HISTORIC LANDMARKS COMMISSION

SUBJECT: REVISED FINDINGS OF FACT FOR NC18-01

SUBJECT: NEW CONSTRUCTION REQUEST (NC18-01) BY CRAIG RIEGELNEGG ON BEHALF OF CARLETON HART ARCHITECTURE TO CONSTRUCT A FOUR STORY HOTEL AT 1 2nd STREET

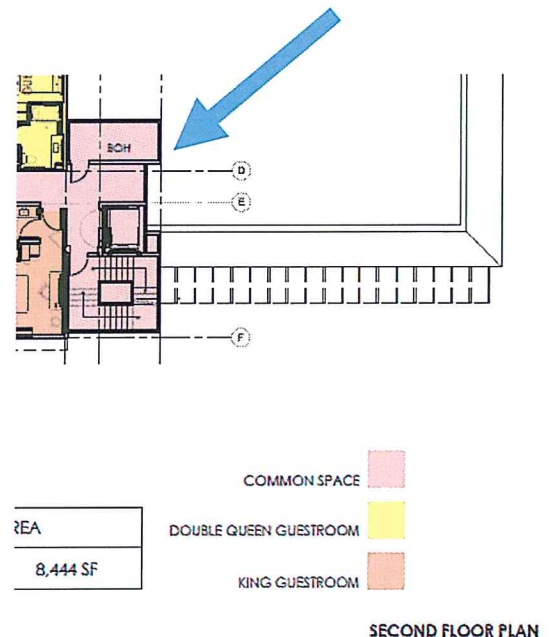
The proposed structure is 154' in length, by approximately 67' wide (with a cut in for a loading zone near the Ship Inn site. While a portion of the first floor is dedicated to parking, the main structure, except the Shin Inn renovation, is 4 stories tall.

The proposed structure is 44' 10" tall to the parapet. The maximum allowed is 45' with stepbacks.

features are not used for human occupancy. The proposed plans on page 39-41 show elevator, stairs and additional common space in the proposed section of the tower that is above the 45'. The applicant has proposed that the Design Review Committee permit the addition of the area referenced as "BOH" as an ornamental tower element. They have stated there is the possibility of including other mechanical equipment in this area. The Design Review Committee determined the proposed additional area in the tower did not constitute ornamental elements.

HLC determined the scale of the proposed four story structure did not meet criteria. While the square footage of the proposed development is allowed by the Development Code, the massing of the structure did not meet criteria. HLC noted that additional modulation at the site, or breaking up the massing would be more appropriate and reminiscent of former canneries along the waterfront with similar scale, but appropriate massing.

Finding: An upgraded landscaping plan to scale, meeting criteria shall be submitted and is noted in the associated Design Review Committee application. The common space noted in the tower above the 45' height limit is not exempt from the maximum height requirements. The applicant shall submit revised plans showing the height has been met.

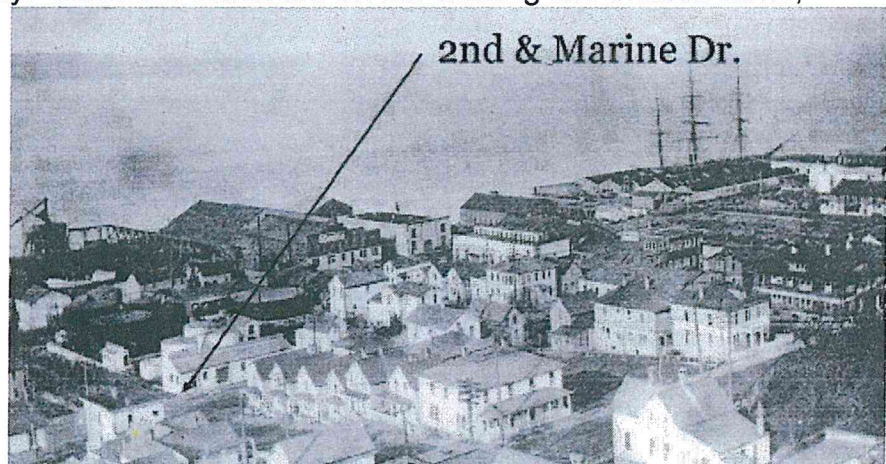
mixture of buildings attached together creating a large expanse of built-up area. The buildings had a mixture of gable and flat roofs in multiple directions (noted to the right).

The proposed building has one large footprint, little modulation in the form, and a flat roof. The applicant notes the style of “waterfront industrial is eclectic.” In Appendix A, it is noted that buildings in “Astoria’s Traditional Industrial Waterfront were vernacular and low-style and always grouped

by function, and often perpendicular to the shoreline.” The proposed building style does not reflect elements of those styles.

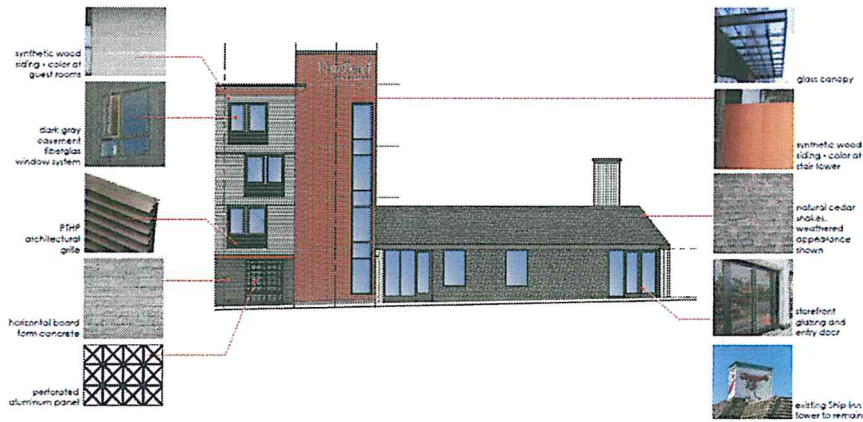
The proposed materials are contemporary which succeeds in differentiating new construction from trying to mimic a historic structure. However, the proposed “Resysta” synthetic wood siding has a grainy texture, that close up provides architectural detailing, but from a distance creates a very flat, plain wall treatment. Two colors are proposed for review by the DRC. The applicant has submitted samples of the proposed materials. Additional materials are noted below:

The HLC determined the materials did not meet compatibility. The synthetic siding, and faux rust colored ornamentation do not meet the intent of the code to differentiate between avoiding mimicking historic structures. While contemporary materials are often appropriate for new construction, HLC determined the proposed materials are not appropriate for the site.

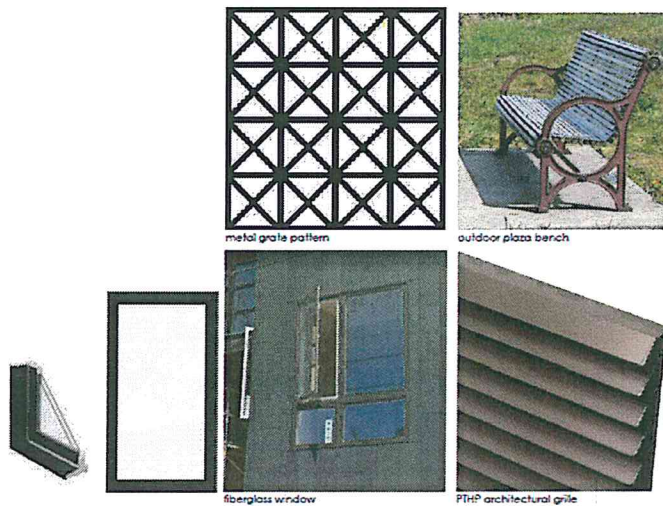
awnings, decks, railings, signage and a materials palette are in the applicant's proposal documents from pages 51A to 65. The applicant has provided two designs for the staircase on the west side of the building. The HLC shall determine if the open design noted on page 62, or the alternative screened in enclosed design on page 52 meets criteria in terms of style, architectural detailing and materials.

HLC determined the unscreened staircase was more appropriate, but the overall style, detailing and materials of the proposed development do not meet criteria and are not compatible with the adjacent historic sites/structures.

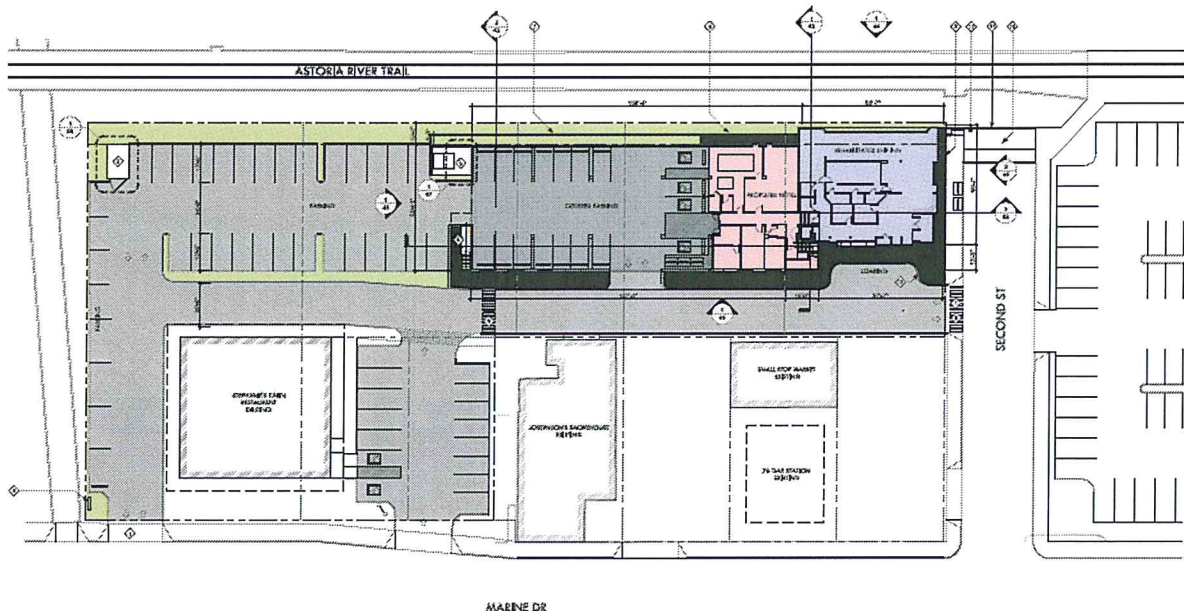
The proposed setbacks are under review by DRC for specific Bridge Vista Overlay criteria to maintain minimum and maximum setbacks in the area. The building is proposed on the north end of the site rather than along Marine Drive.

The site under common ownership by the applicant is an L shape and the long portion extends east west along the Columbia River. By reusing the Ship Inn structure, the setbacks for Ship Inn will remain where the existing footprint is. The main portion of the hotel will run parallel to the River.

The applicant did not provide additional details for the siting of the structure. The proposed siting was found not to meet criteria for siting and incorporating the proposed renovations to the Ship Inn did not meet the criteria for appropriate setbacks. Commissioners noted the orientation of the building cut off visual access to the riverfront and did not provide the required setbacks.
